# RUGER PRECISION RIFLE®

## PRODUCT SAFETY BULLETIN

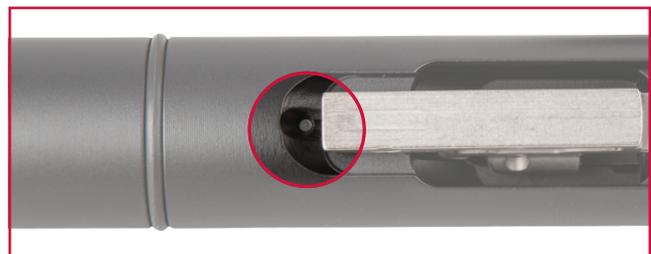
Some Ruger Precision Rifles may experience interference between the aluminum bolt shroud and the cocking piece (also known as the firing pin back). In rare instances, the interference can disrupt the firing mechanism and cause it to not function properly.

Possible results of this interference are light primer strikes or, in extreme cases, the rifle may not fire when the trigger is pulled. If the rifle fails to fire when the trigger is pulled, it may fire when the bolt handle is subsequently lifted.

Replacement bolt shrouds of the new design are easily identified by the presence of a round dimple on the angled surface directly behind the firing pin back.

If your bolt shroud has this mark, it was manufactured with the new design and **no further action is needed**.
